User Safety Notice

50 ft. / 15 m. Workman® Self-Retracting Lanyard

October 28, 2015

Yellow Tamper Evident Paint

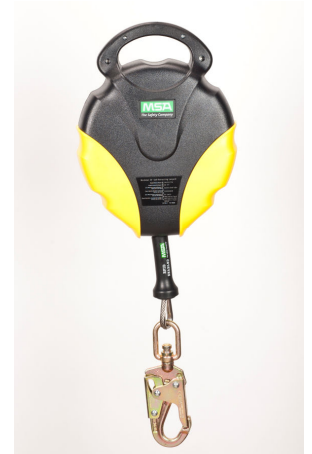
We have determined that a small percentage of Workman 50 ft. / 15 m. SRLs manufactured from January through August of 2015 may have an improper brake nut torque setting. This condition is not detectable when performing the normal pre-use inspection procedure. SRLs with this condition may not arrest a user's fall or may not arrest it within the specified maximum arrest distance.

Please note that the replacement SRLs may also have a “date made” from 01-2015 through 08-2015, but include yellow tamper evident paint on the exterior housing screw heads near the handle, as shown in the photo below. These SRLs are new units that were factory upgraded to include a new brake assembly and are acceptable for use.

It is important that you immediately mark all affected SRLs “UNUSABLE” and then discard or return them to MSA, unless they pass the special inspection. SRLs that pass the special inspection are acceptable for continued use. Please cut the cable on any SRLs that are discarded to ensure that they cannot be used.
